Subject: Sequoyah Fuels Corporation, Docket – 40-8027
Response to Draft Safety Evaluation Report – Reclamation Plan
(TAC L52511)

**Sequoyah Fuels Corporation
Draft Safety Evaluation Report (DSER)
Response to Remaining Open Issues as of May 2006**

FIGURE 1
STREAM 005 DETAIL

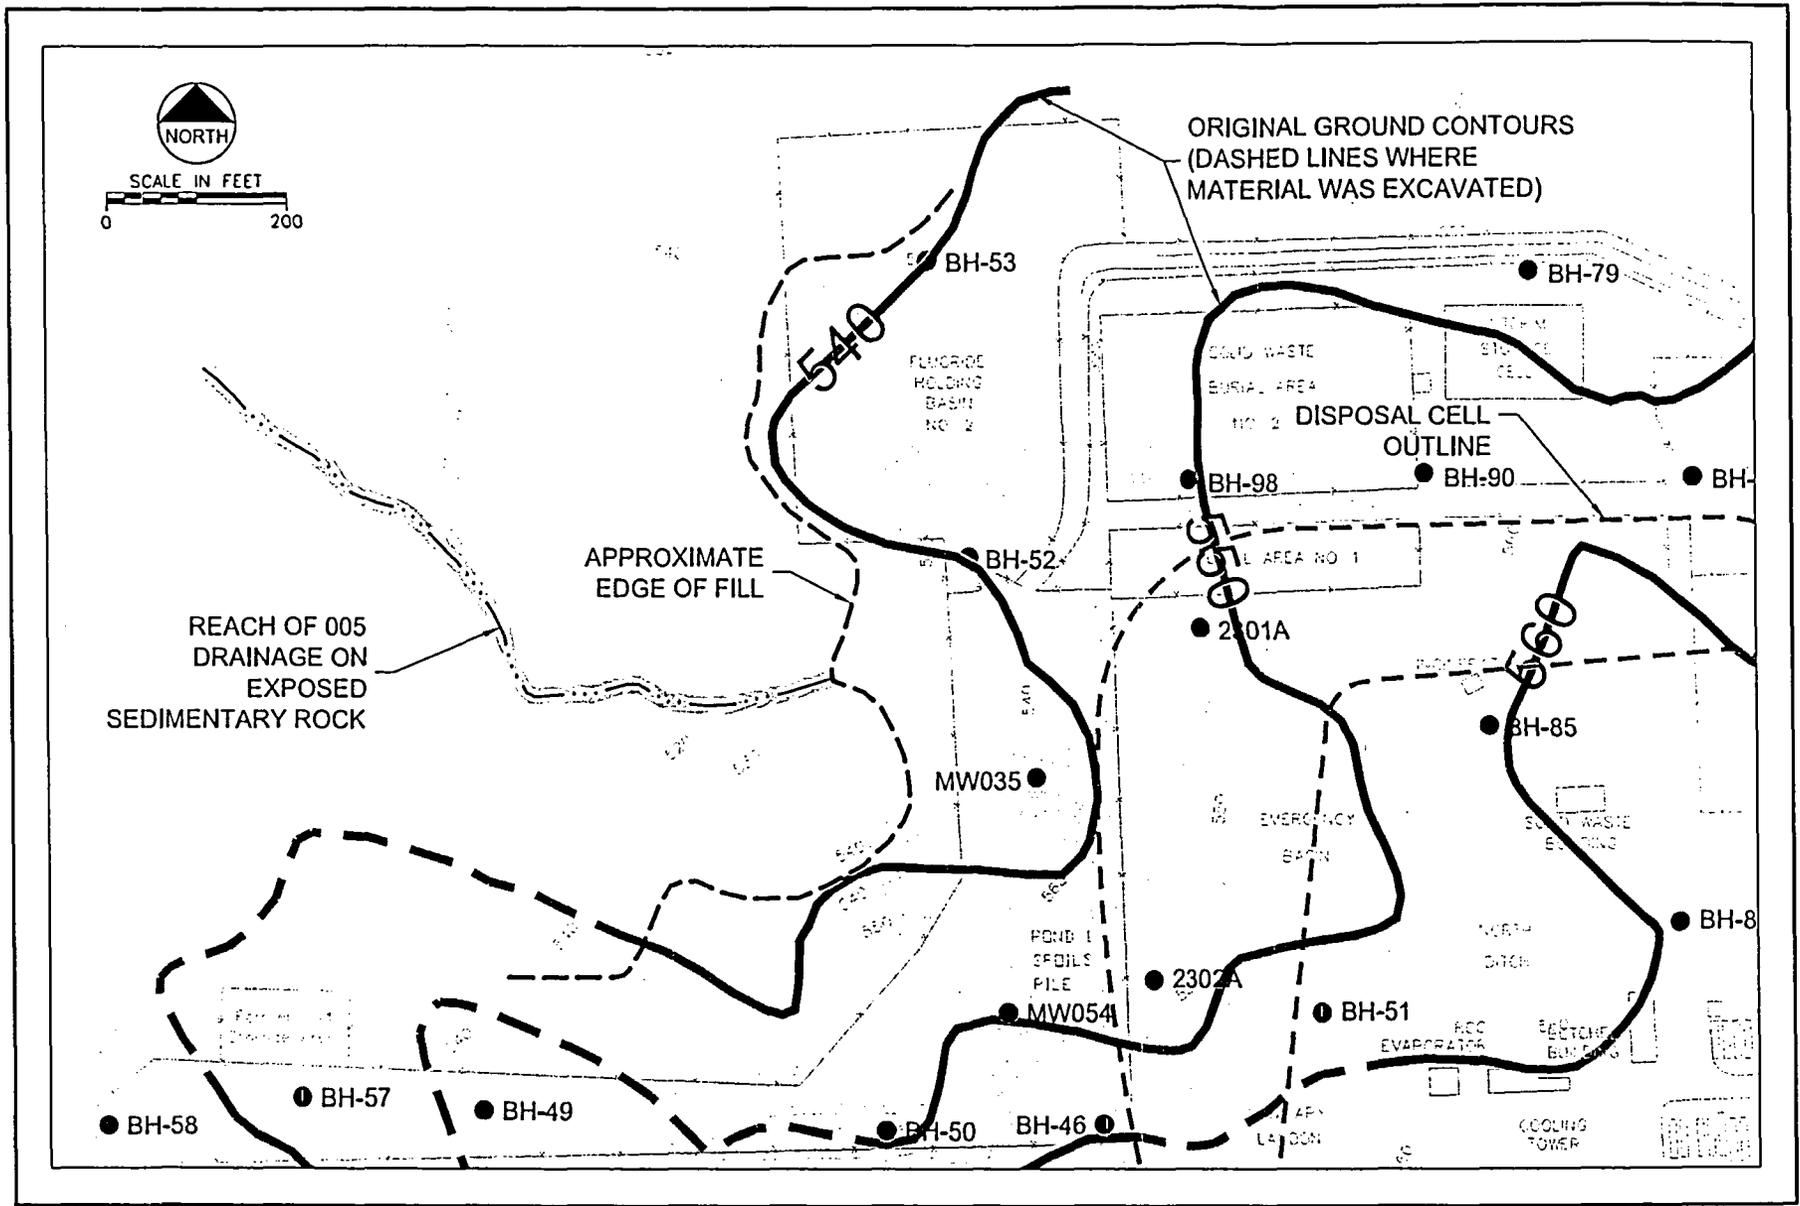
1. **DSER OI.01** The licensee needs to provide an analysis regarding the potential for Stream 005 to encroach upon the foot or apron of the proposed cell. (SER Section 2.4.2)

This open issue (OI) and OI.20 pertain to erosion of Stream 005 and its effect on the west side of the disposal cell. The geomorphology of Stream 005 is addressed under OI.01 and the details of erosion protection are addressed under OI.20.

The SFC facility is underlain by sandstones and shales of the Pennsylvanian Period Atoka Formation (described in the Reclamation Plan). The bed of Stream 005 was eroded in the sedimentary rocks to its current level prior to construction of the SFC facility, when the catchment area draining to Stream 005 was larger than it is at the present time. The contributing catchment area to Stream 005 will be reduced further after disposal cell construction.

The bed of Stream 005 west of the disposal cell has exposed sandstone and shale, in the reach shown in Figure 1. East (upgradient) of this reach of Stream 005, the bed slope is steeper due to fill placement by SFC. Disposal cell construction with erosion protection material placement (described in OI.20) will reduce the bed slope of Stream 005 in this area of fill placement, as shown in Figure 2. This has been designed to protect against gully intrusion from Stream 005 as well as provide erosion protection from runoff from the west slope of the disposal cell.

FIGURE 2
EROSION PROTECTION FACILITIES AT TOP OF STREAM 005 DRAINAGE

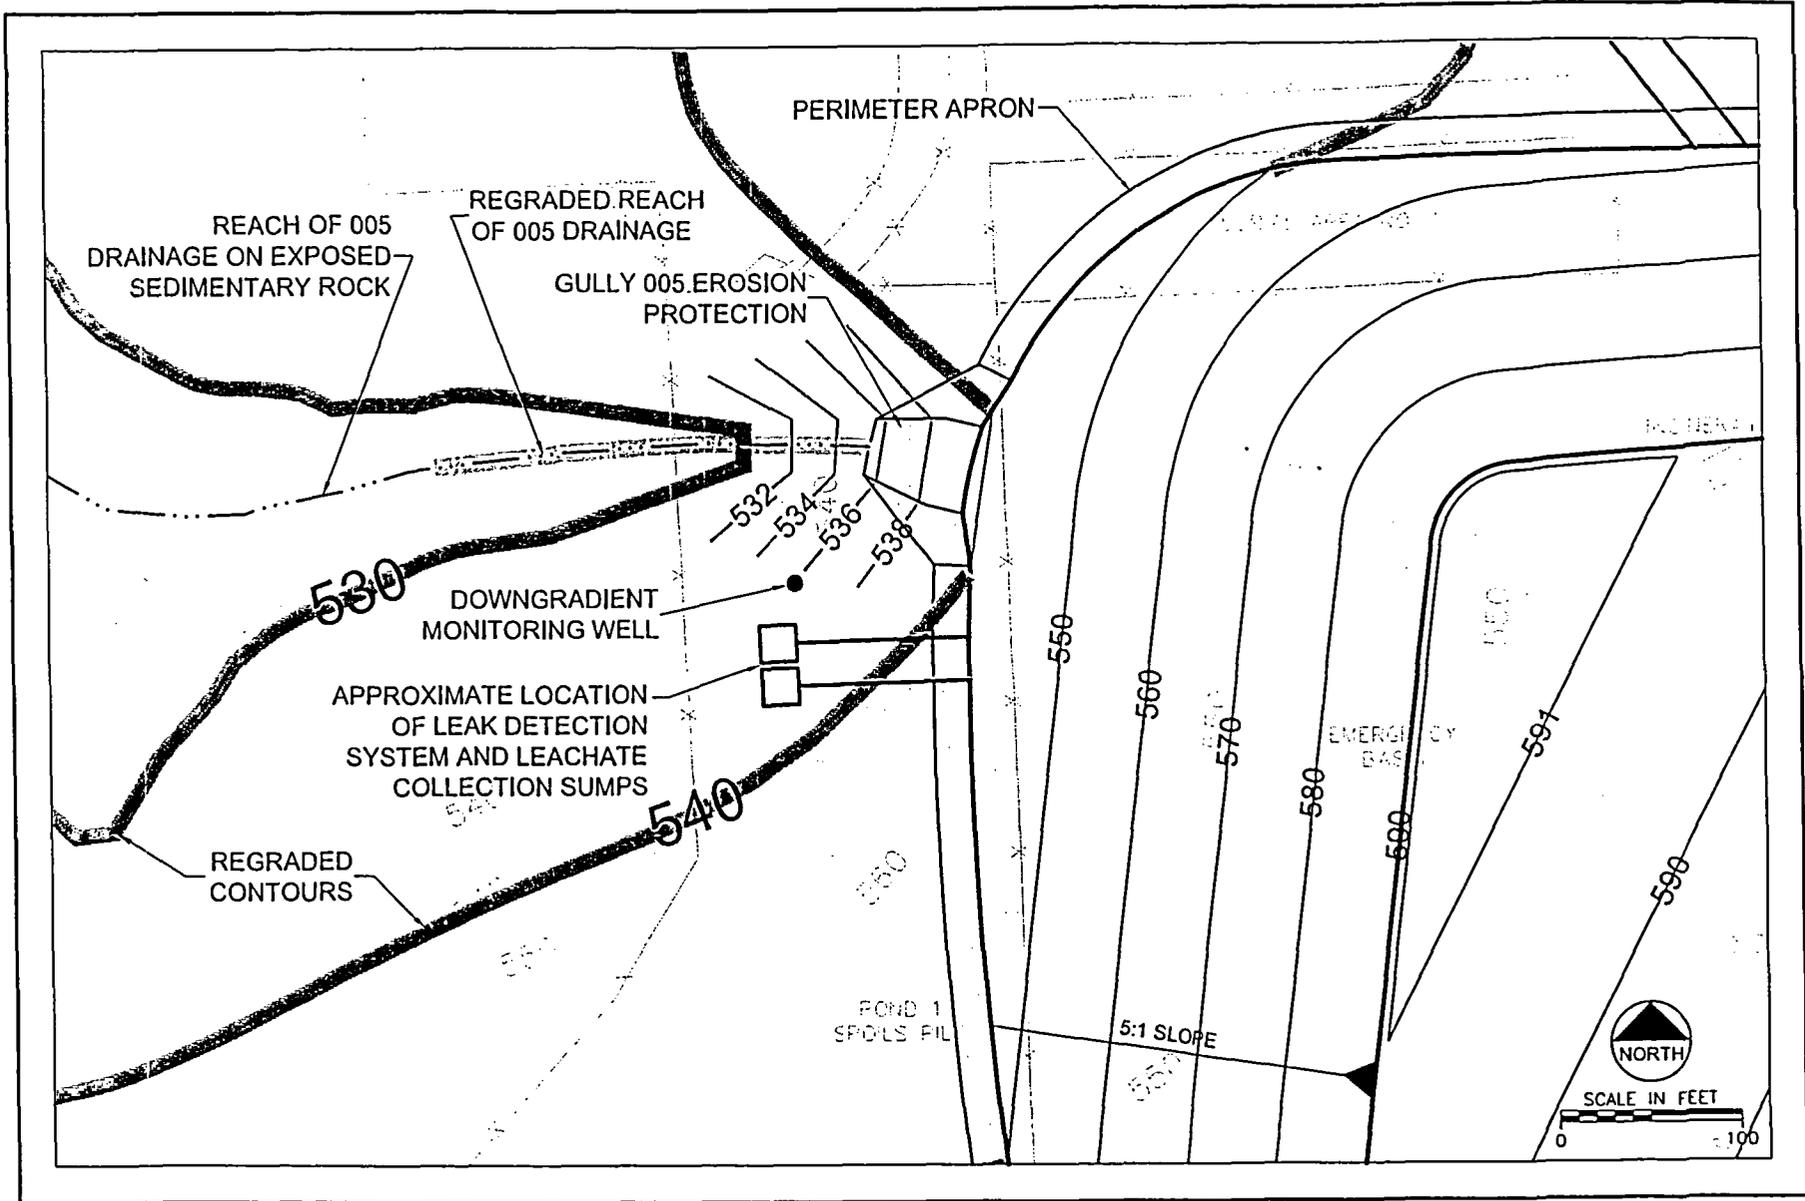
9. **DSER OI.20** The licensee needs to provide a design for rock armor protection of stream 005. (SER Section 4.5.1.3)

This feature has been provided and enlarged, based on discussions with NRC. The updated rock armor protection layout is shown in Figure 2.

On the north, west, and south sides of the disposal cell, runoff at the toe of the slopes is directed over the perimeter apron to natural ground. As shown on the reclaimed disposal cell layout (Reclamation Plan Attachment A), approximately 5.4 acres of land between the cell and the east facility boundary line will drain towards the east side of the cell. This flow will be intercepted by the diversion channel on the east side of the cell that will direct flow to the north and south of the cell (Reclamation Plan, Attachment A). The perimeter apron on the east side of the cell is extended to a 60-foot width and will be shaped as a trapezoidal channel, with a channel depth of one foot to accommodate this flow. The rock channel will have the same rock size as the perimeter apron rock (a median size of 5.7 to 8.0 inches), and will be placed in a minimum 24-inch thick layer.

A rock apron has been included in the disposal cell design to provide protection in the unlikely event of headward erosion from Stream 005. The rock apron is a downstream extension of the perimeter apron at the toe of the disposal cell slopes and is located where runoff from the west slope of the disposal cell discharges into the east end of Stream 005. The rock apron will be keyed into underlying shale and constructed with the perimeter apron rock.

The rock apron was sized according to guidelines in NUREG 1623, with design calculations presented in Appendix D of the Disposal Cell Construction Plan (Reclamation Plan Attachment E). Scour depth was estimated using the procedures presented in the U.S. Department of Transportation, Hydrologic Engineering Circular 14 (US DOT, 1975). For this calculation, runoff from the west slope of the disposal cell and overland flow from approximately 1.5 acres to the west of the disposal cell discharge at the head of Stream 005. The maximum scour depth is estimated to be approximately 5.4 feet deep. Drill holes near the head of Stream 005 (BH-42 and BH-47) show shale bedrock at a depth of less than 7 feet.

FIGURE 3
PARTICLE-SIZE DISTRIBUTIONS OF EROSION PROTECTION AND
BEDDING MATERIALS

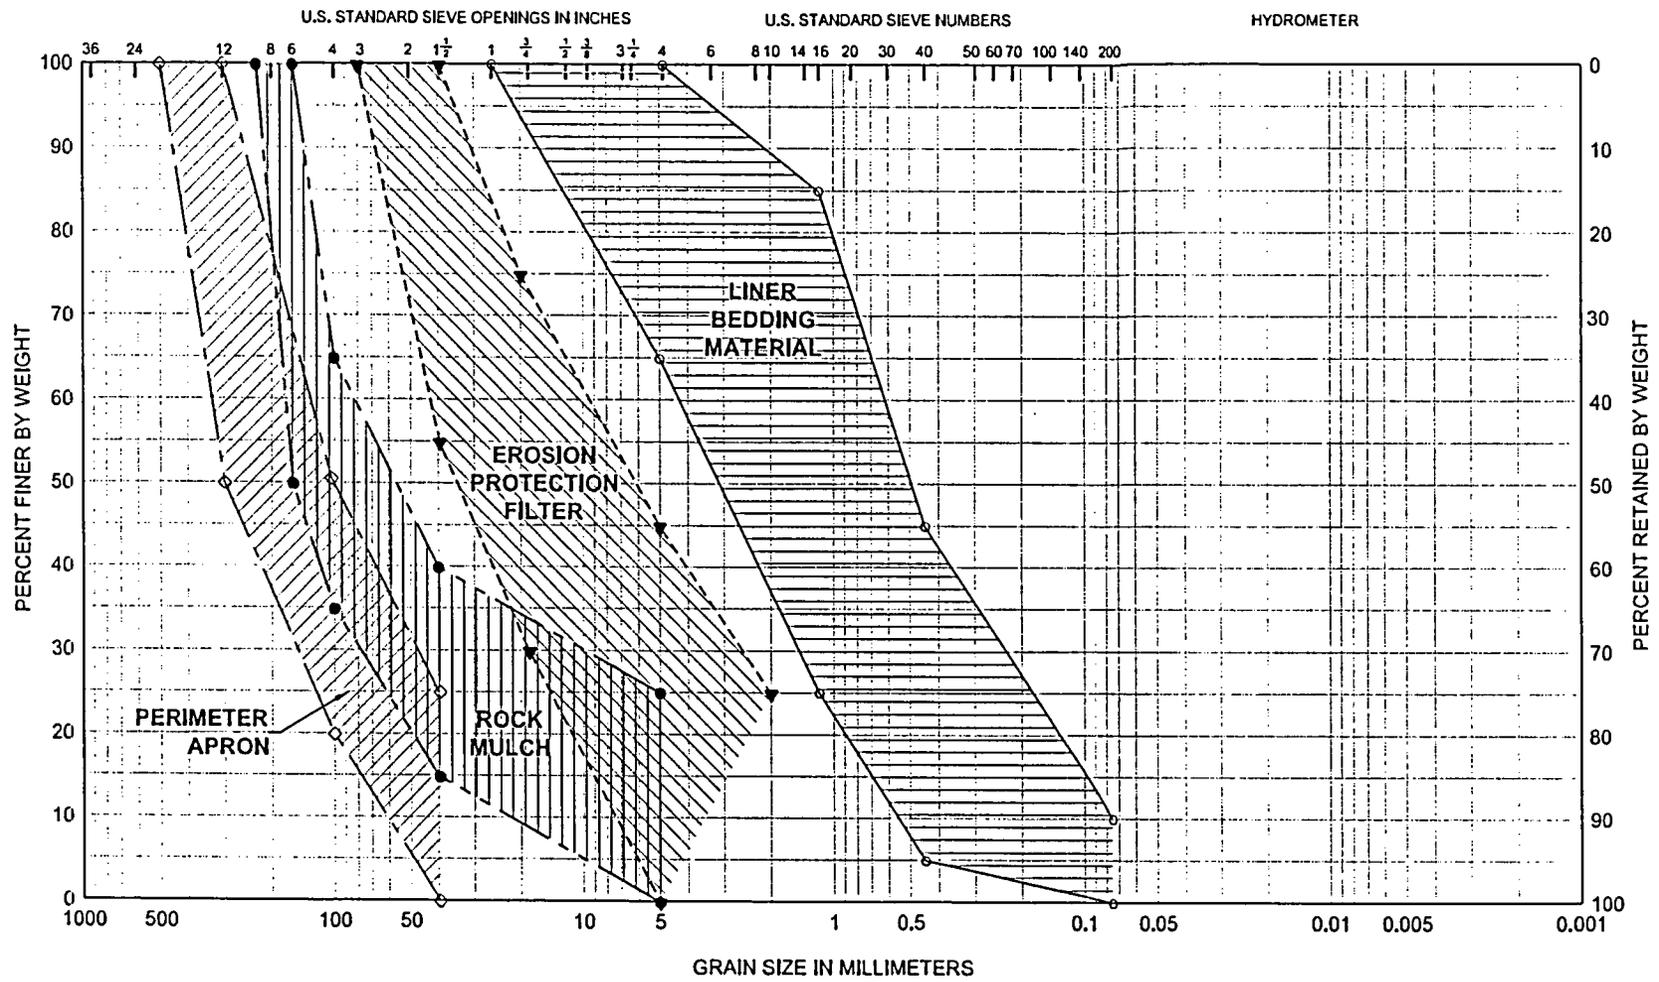
10. **DSER OI.21** The licensee needs to provide specifications for riprap rock gradation. (SER Section 4.5.2)

The gradation of the rock mulch layer on the side slopes of the disposal cell have been modified to have a median size of 3.4 to 4.7 inches (depending on particle angularity). The rock gradation recommendations, as given in NUREG 4620, Section 4.2.2, pertain to clean riprap. The slope protection planned for the disposal cell is a rock mulch, with the voids filled with smaller particles.

The Technical Specifications for rock mulch material have been modified to be more closely aligned with the median rock size. The rock mulch material will have the following gradation requirements (for material from a nearby limestone quarry):

<u>Sieve Size</u>	<u>Percent Passing</u>
9-in	100
6-in	50-100
4-in	35-65
1.5-in	15-40
No. 4	0-25

This gradation is shown in Figure 3.

The Technical Specifications for perimeter apron material have been modified to be more closely aligned with the median rock size. The perimeter apron material will have the following gradation requirements (for material from a nearby limestone quarry):

<u>Sieve Size</u>	<u>Percent Passing</u>
16-in	100
12-in	50-100
6-in	50-100
4-in	20-50
1.5-in	0-25

This gradation is shown in Figure 3.

SEQUOYAH FUELS CORPORATION	
TITLE: <i>Location of Wells MW025 and MW075</i>	
PREPARED BY: <i>SCM</i>	FILENAME: <i>WellLocsSulfate.dwg</i>
REVIEWED BY: <i>CLH</i>	FIGURE NO. 4
DATE: <i>27 Jun 2006</i>

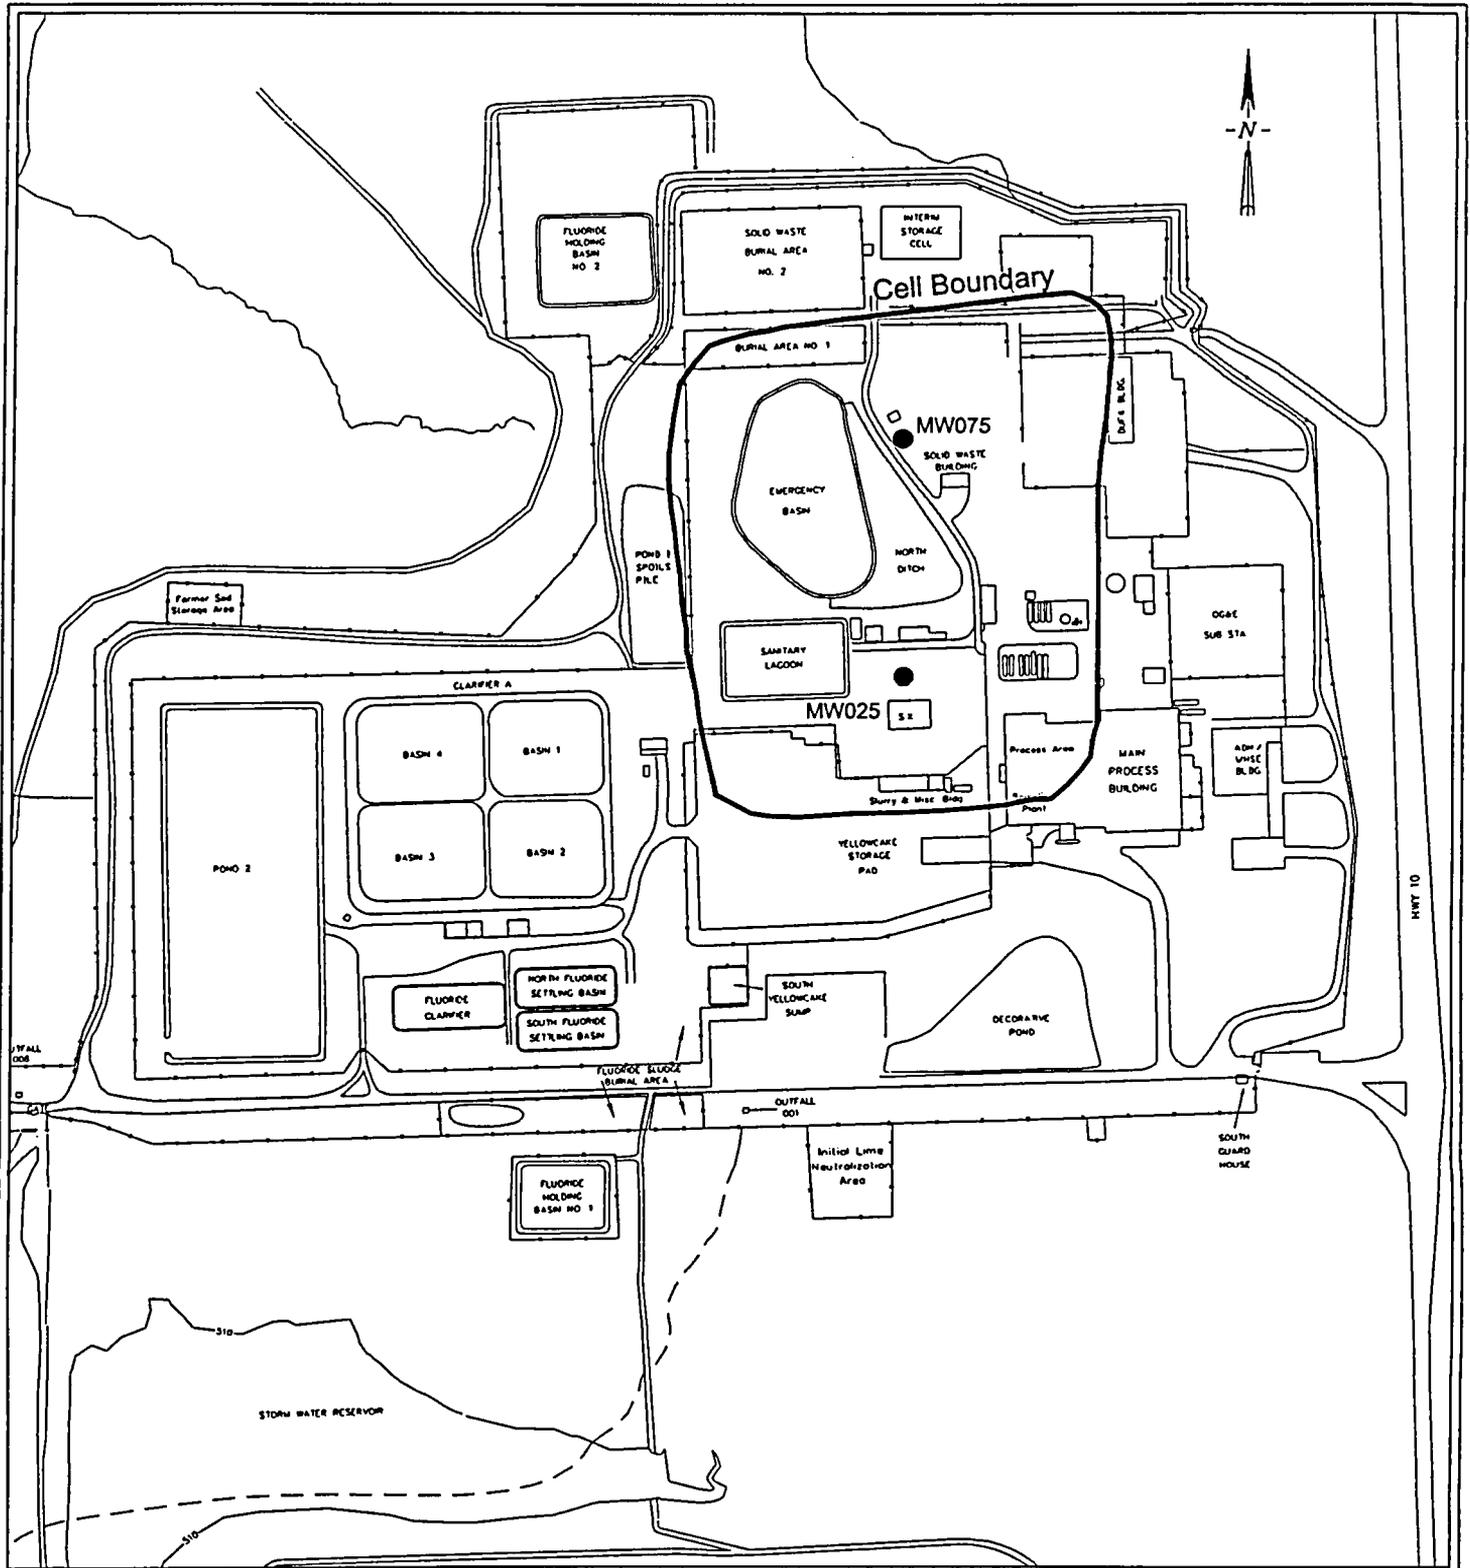
13. **DSER OI.32** The licensee must perform an analysis to verify that some proposed detection parameters will migrate at rates comparable to uranium or propose nonhazardous constituents as detection monitoring parameters. (SER Section 5.4)

However, as requested an additional review has been conducted to determine if there would be any unique and conservative parameter that could be used in a conventional way for prompt detection of leakage. It has been determined that sulfate can serve as an appropriate non-hazardous constituent that can be used for prompt detection of seepage from the lined disposal cell. Sulfate is typically used as an indicator parameter since it is a

very conservative constituent in groundwater flow. Sulfate will be transported with essentially no retardation. All of the hazardous constituents have some retardation, therefore sulfate will be the first indicator of seepage.

Limited data exists for sulfate concentrations in groundwater. Two samples from the terrace/shale 1 layer (wells MW-025 and MW-075) were taken in 2001 and analyzed for sulfate. These data indicate that the background sulfate concentrations in the terrace/shale 1 layer are relatively low (6.7 and 278 mg/l). Figure 4 shows the location of the wells relative to the disposal cell and Table 1 presents the complete set of analytical results for these wells for the 2001 sampling.
